# 561 Horotiu Road

Proposed Commercial Development

## OPERATIONAL NOISE S92 QUERIES

Reference: J003176.S92.2

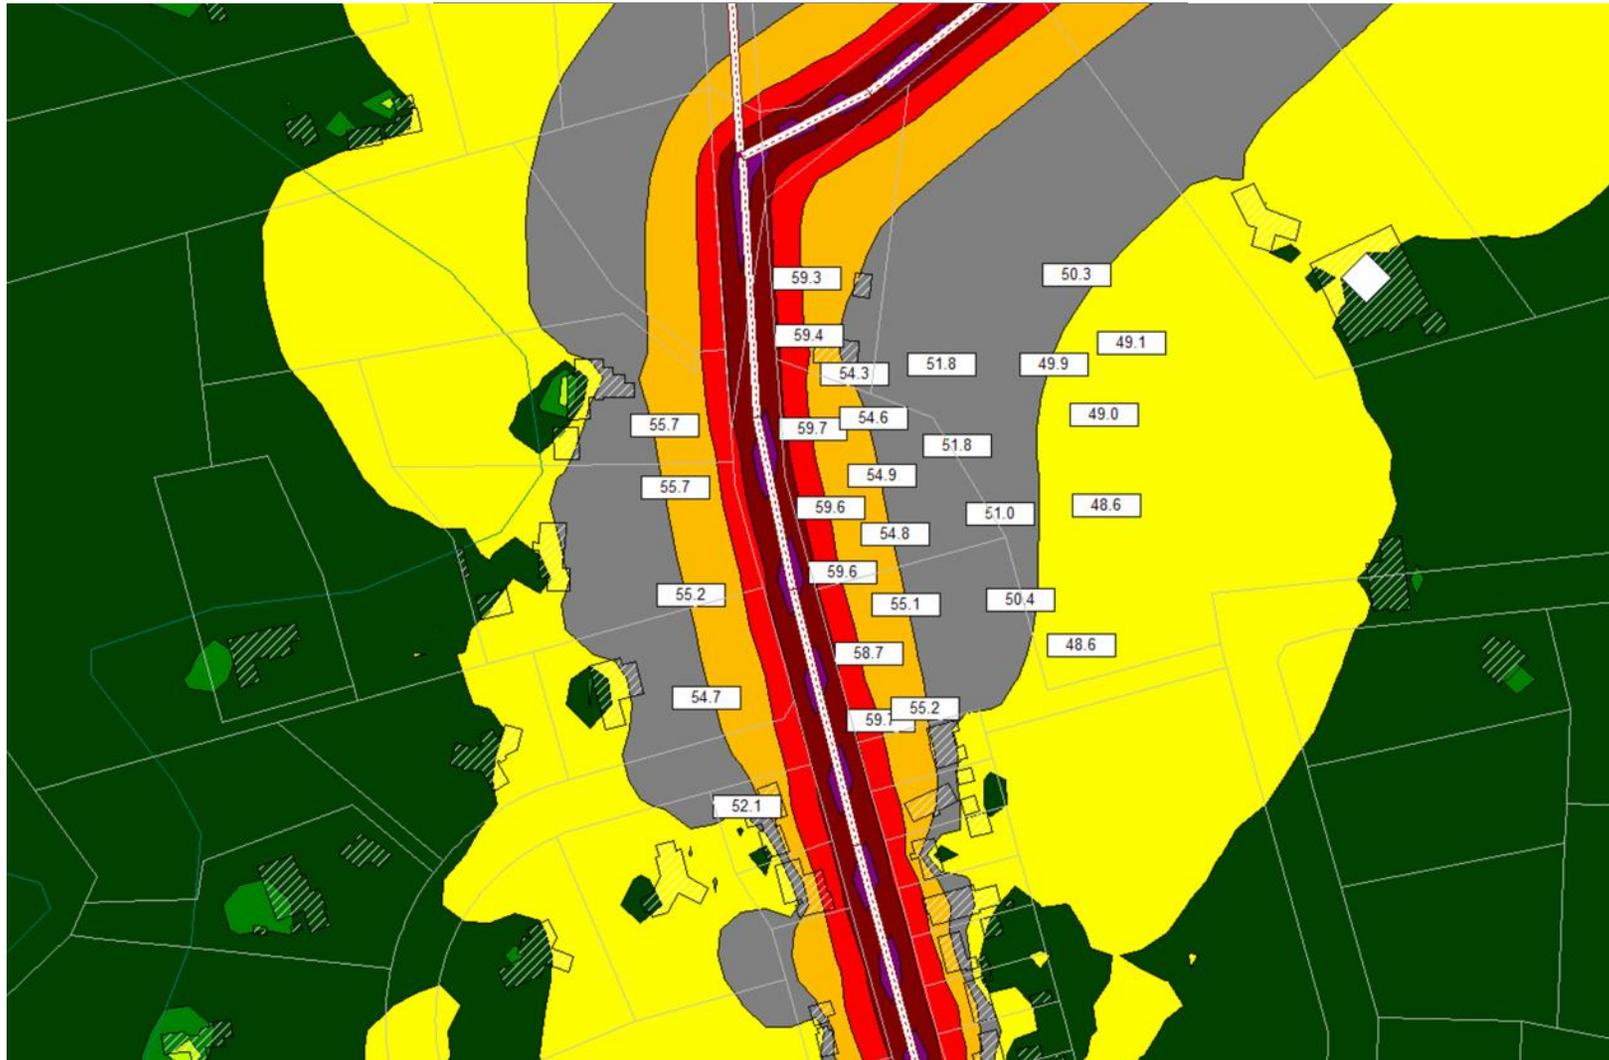
*Item 1: Undertake background sound level measurements at Position 3 in the evening and night-time periods.*

The graphs in the pages below show the noise contours associated with traffic only. We note the following conservative measures incorporated into the model:

- Daytime noise levels from traffic:
  - Predicted to be  $LA_{eq}$  59dB at the side of the road. This collates with the daytime measurement at Location 1 (also at the side of the road), where  $LA_{eq}$  was 60dB. Noise level.

- Predicted to be  $LA_{eq}$  52dB at 25-30m from the roadside, which also collates (albeit conservatively 1db lower) with the measure value at location 3 where  $LA_{eq}$  was 53dB

- Evening noise levels from traffic:
  - Predicted to be between  $LA_{eq}$  51dB ( $\approx L_{10}$  54dBA) at the roadside, down to  $LA_{eq}$  43dB ( $\approx L_{10}$  46dBA) at the eastern boundary of the subject site.

- Night-time noise levels from traffic:
  - Predicted to be between  $LA_{eq}$  39dB ( $\approx L_{10}$  42dBA) at the at the roadside, down to  $LA_{eq}$  31dB ( $\approx L_{10}$  34dBA) at the eastern boundary of the subject site.

*Figure 1 - Elevation view from Northern boundary with 572 Horotiu Road*

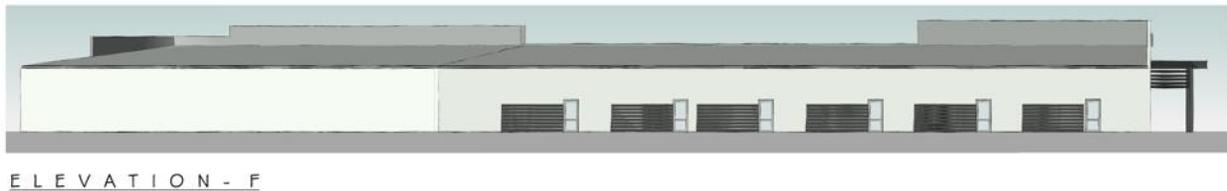
*Item 2: Provide commentary around predicted night-time noise levels at the boundary with 557 Horotiu Road and Lot 4000 DP 527122, compliance and level of effects.*

We note that only the rightmost occupancy (takeaway) as depicted by the glazed door at the right, is expected to have any notable mechanical plant requiring penetrations through the façade (e.g. extraction fans). The other occupancies are all either retail or in the case of the superette at the leftmost occupancy would only have internal equipment, and furthermore has a solid façade facing the north and east with no glazing or penetrations.

It is key to consider that the operation of the takeaway does not extend into the night time hours, and as such any mechanical plant requiring external noise (e.g. extraction fans) would not operate during night hours.

Operations would only extend to the evening hours no later than 10pm. During these evening hours, we note that noise levels from traffic are predicted to be circa 46dBA at the boundary close to the neighbouring building. This is noted to be higher than the cumulative noise from the operations of the proposed facility during these hours.

Regarding night hours, which pertain mainly to internal equipment, it would be expected that the glazed door would be closed during night time for security purposes. It is also assumed that the takeaway would include fridges and freezers for preservation of perishable food items.

Based on noise generated by commonly used commercial chillers and freezers, and provided the door complies with the requirements of the acoustic report (i.e. STC 31) noise levels external to the building from the takeaway shop would subjectively be inaudible at the boundary during night time. In proximity to the glazed door of the proposed takeaway unit, noise levels would be less than 30dBA and absent tonality on account of attenuation through the façade and door glazing.
